SUNDRY NOTICES AND REPORTS ON WELLS

8. Well Name and No.
ALSCOTT FEDERAL #29. API Well No.
30 015 2214210. Field and Pool, or Exploratory Area
N TURKEY TRACK (MORROW)11. County or Parish, State
EDDY COUNTY, NM

SUNDRY NOTICE SPECIAL STIPULATIONS

Alcort No 2

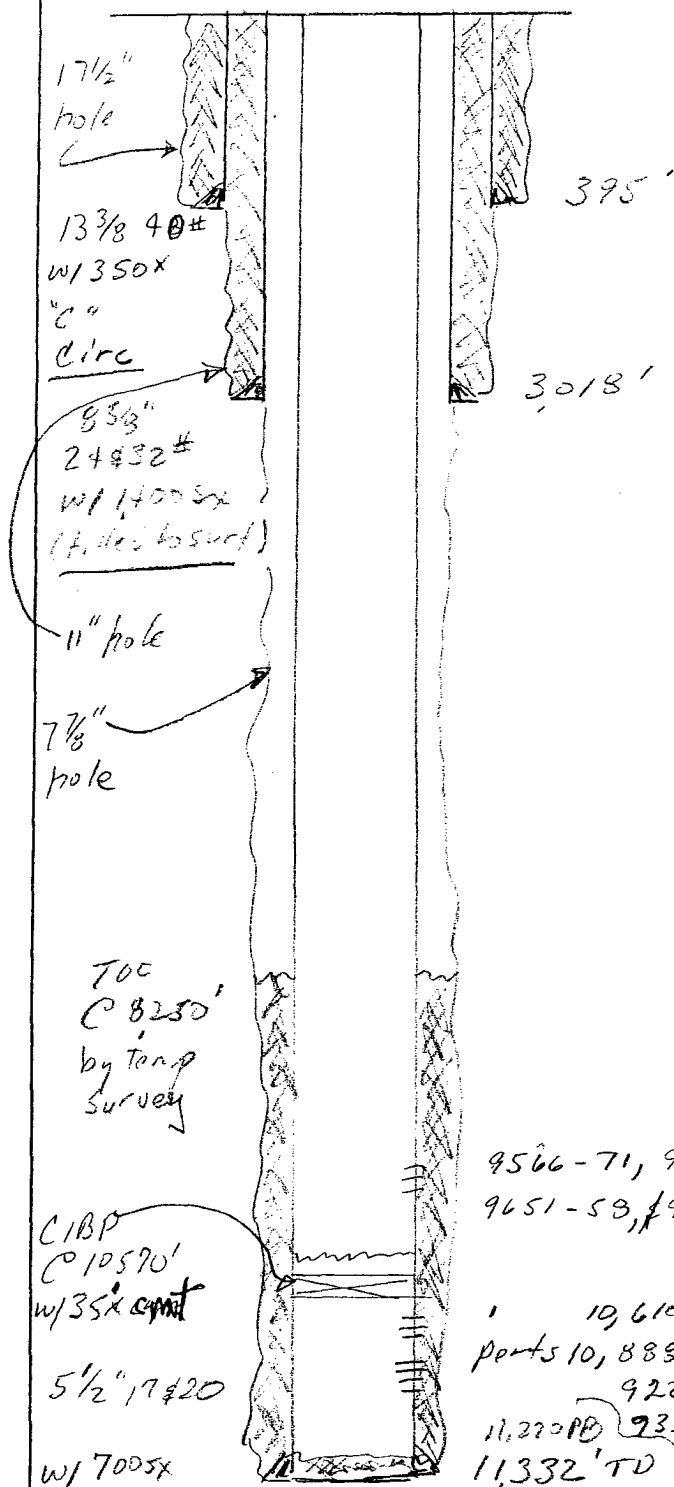
1. Approval is granted to plug this well with the following modifications:
2. BLM records indicate that three CIBP's were set in this well in February 2002 @ 11,050', 10120' and 9500' respectively, with 35' of cement bailed on top of each CIBP. This work was witnessed by a BLM Inspector. Apparently the CIBP reported as being set @ 10570' on 6/21/97 was drilled out without a sundry being filed to request or report that work. **If you can verify this information, the setting of a CIBP @ 9500' in the proposed procedure should be replaced with tagging the cement on top of the CIBP currently @ 9500', then running a CIT or pumping 48 sacks of class H cement on top of the cement @ the PBTD.**

3. When 5.5" casing is cut and pulled set stub plug size according to the criteria below. If the casing is pulled to down below 6595', add a 40 sack cement plug @ 6595', for the top of the Bone Spring. If the casing is pulled above 6595', perf and squeeze 40 sacks of cement @ 6595' leaving 16 sacks inside of the casing. If the casing is pulled below 8595' the plug must come above this depth or a plug must be added between that plug and the one @ 6595' to reduce the distance between these plugs to less than 2000'.

4. Add a 26 sack plug @ 895' for the top of the Delaware.
5. Add a 26 sack plug @ 445' for the surface casing shoe.
6. The surface plug must be at least 100'.

7. The plugs @ the 5.5" casing stub, 3068' and 455' must be tagged.
8. The balance of the procedure is approved as submitted
